**Proposed Plan
for Soil, Sediment, and Surface Water
at RVAAP-42 Load Line 9**

**Former Ravenna Army Ammunition Plant
Portage and Trumbull Counties, Ohio**

**SUBJECT: "RAVENNA ARMY AMMUNITION PLANT PORTAGE/TRUMBULL
COUNTIES, FINAL, PROPOSED PLAN FOR SOIL, SEDIMENT,
AND SURFACE WATER AT RVAAP-42 LOAD LINE 9" DATED
MARCH 31, 2017**

Attachment 1.	Ohio EPA Comments and Responses
---------------	------------------------------------

Figure 3. Load Line 9 Site Features

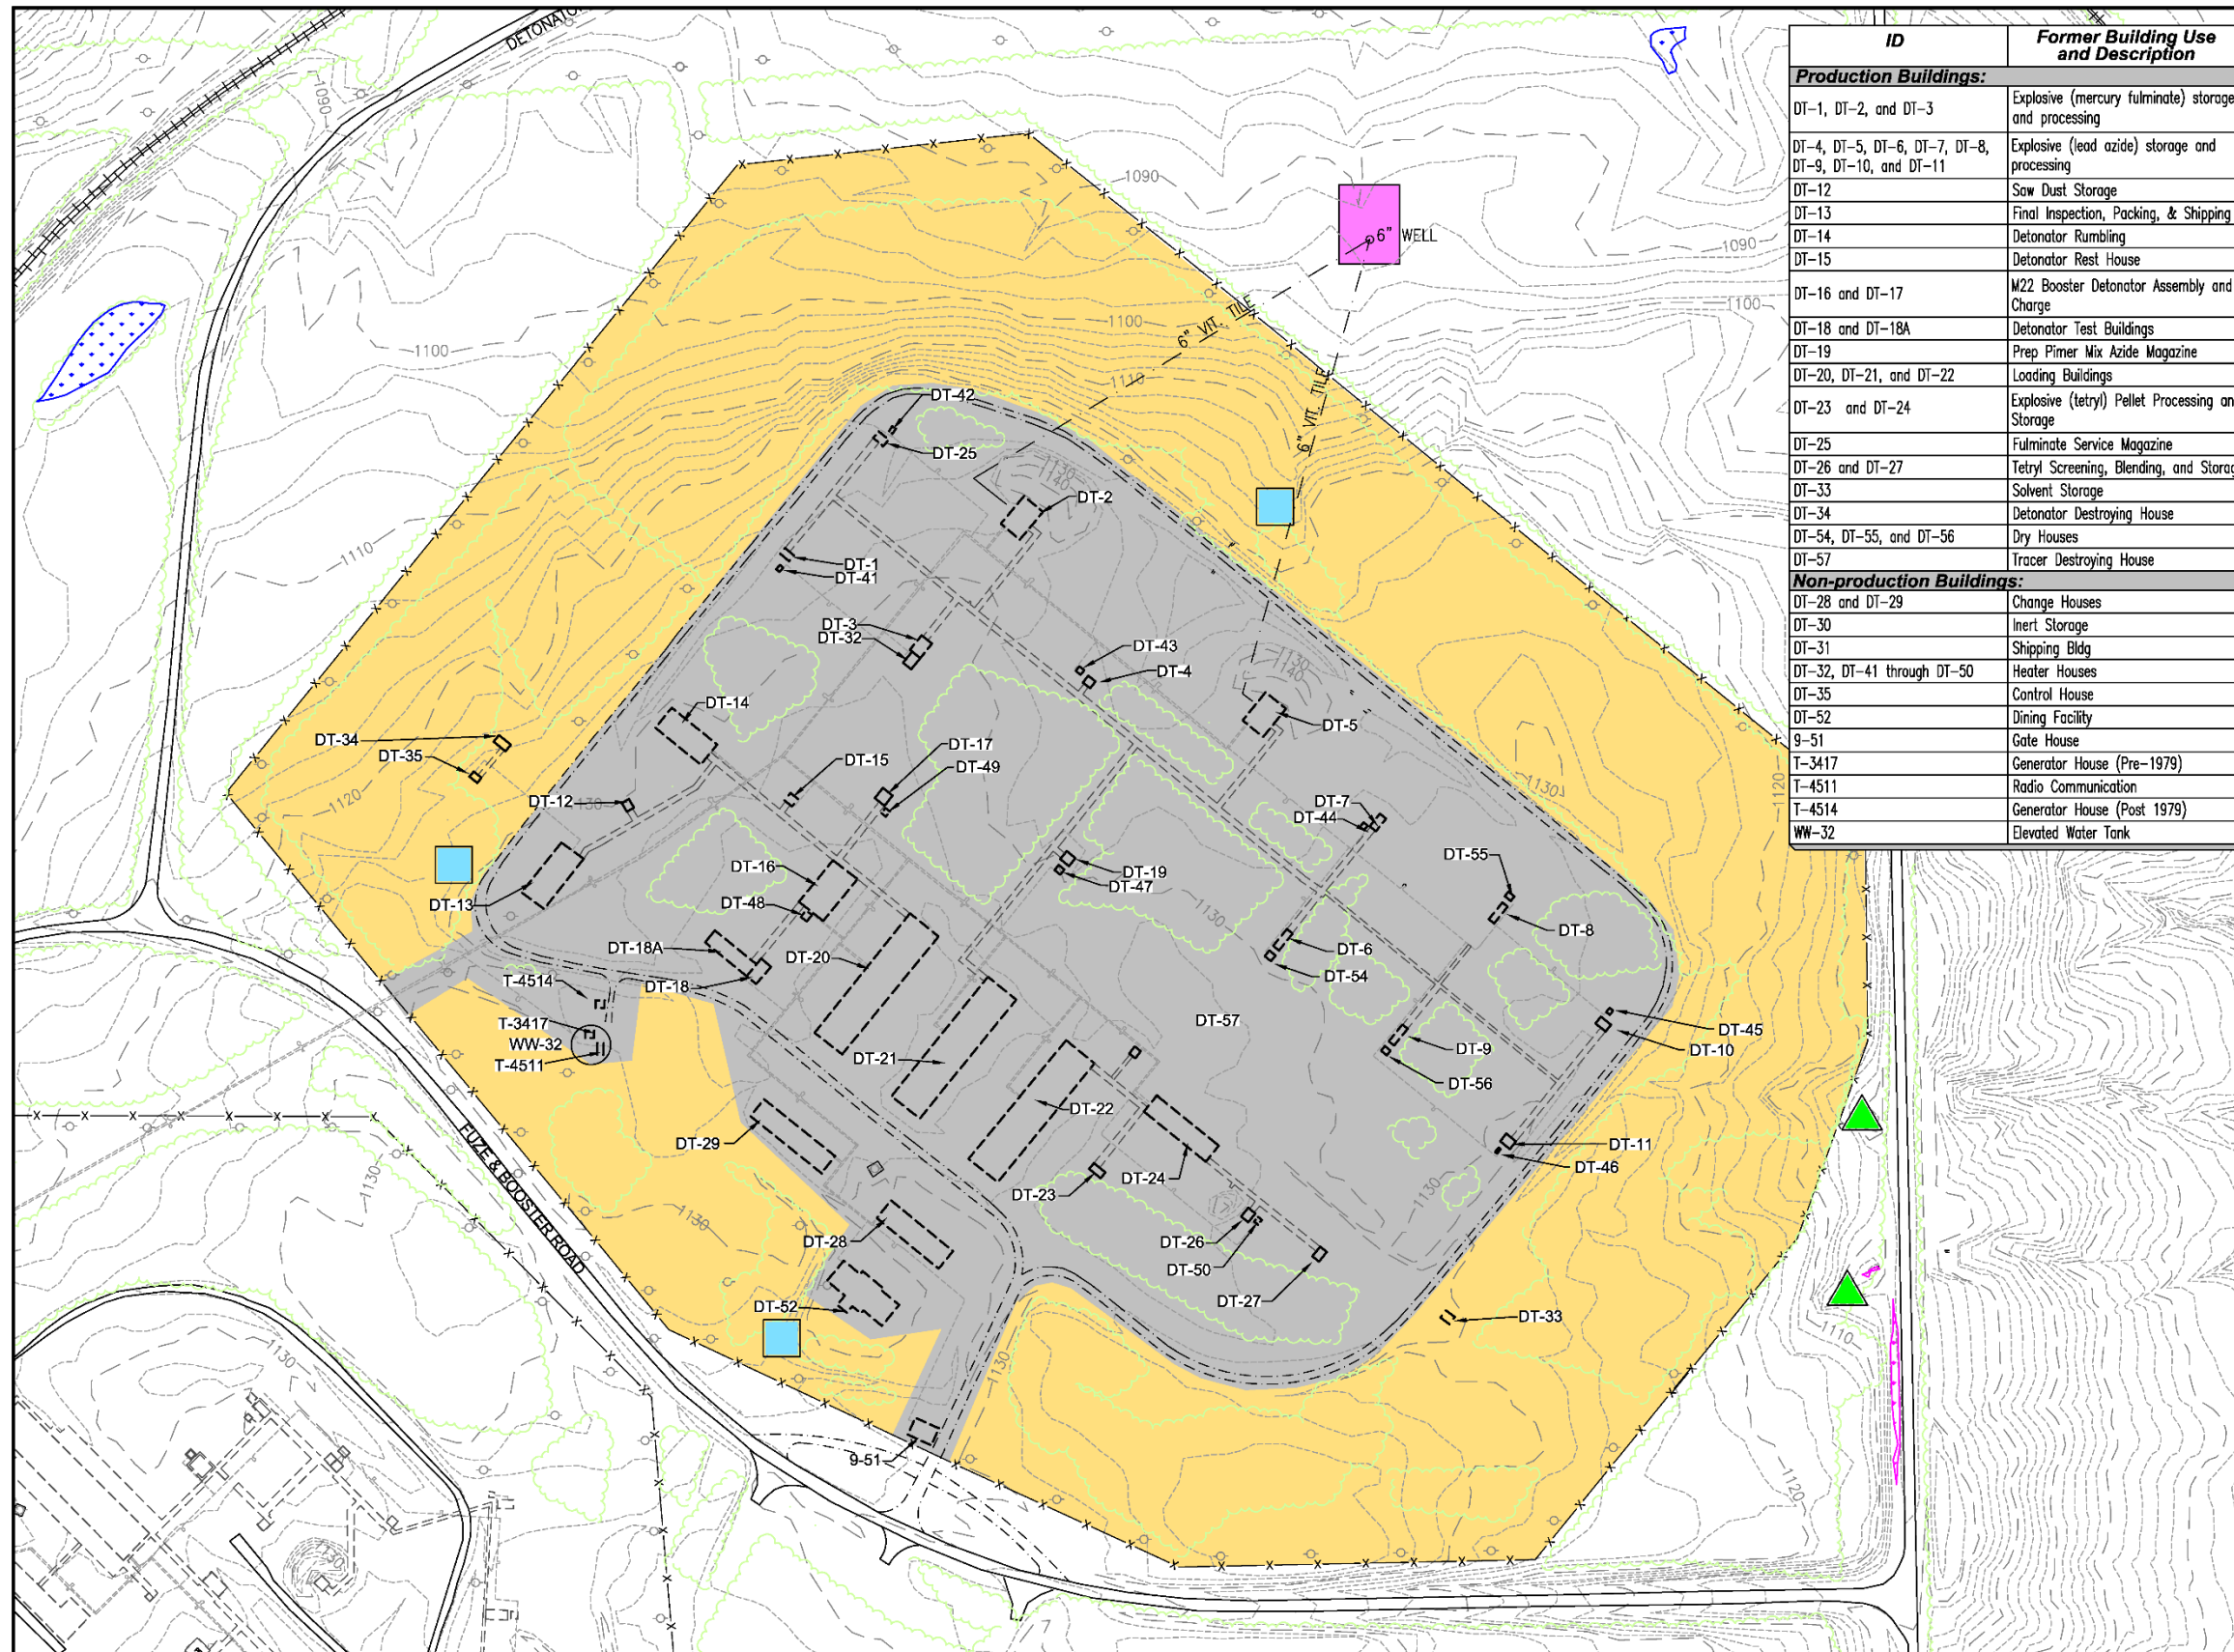
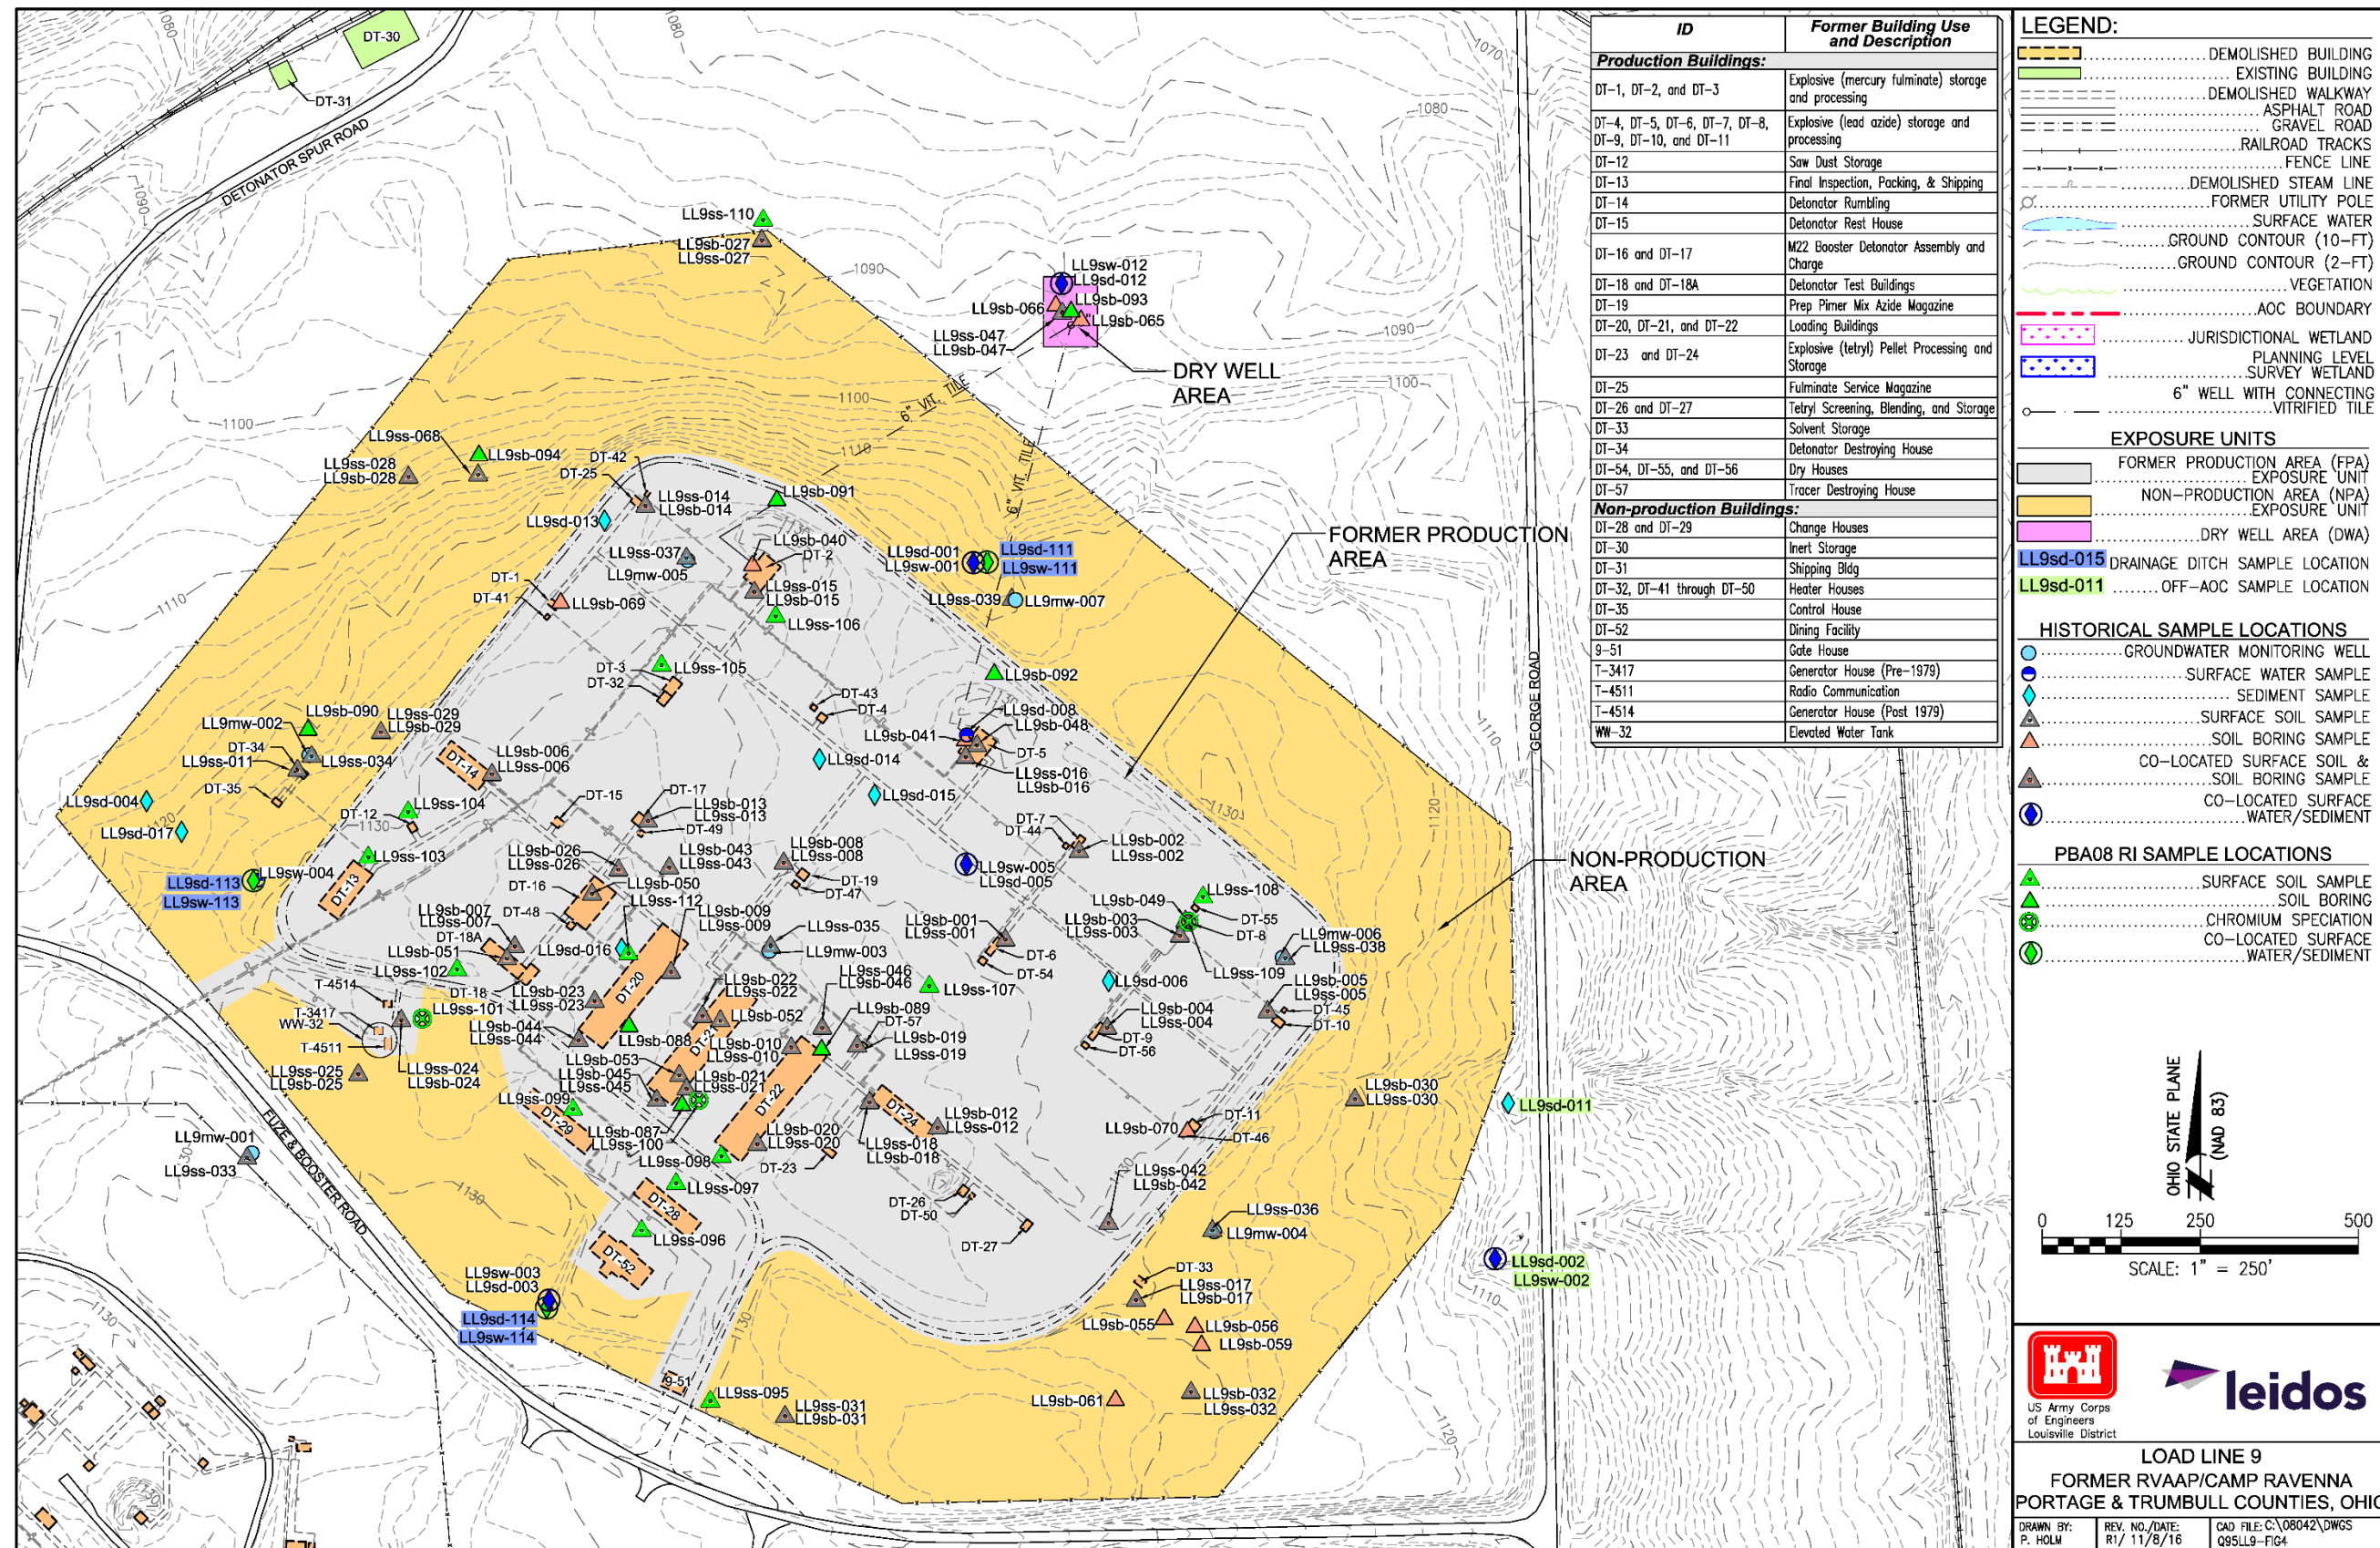
Comment 2, regarding the dry well that is identified in two figures, was not adequately addressed and may have been misread. Please discuss exactly what the "dry well" is (including physical description), the function during operational years, and any proposed remediation or removal.

Army Response: Agree. The following sections have been revised. Please note that the dry well area (DWA) is discussed in the Human Health Risk Assessment. The HHRA states “Additionally, there were no COCs identified for any receptor for surface soil in the DWA.”
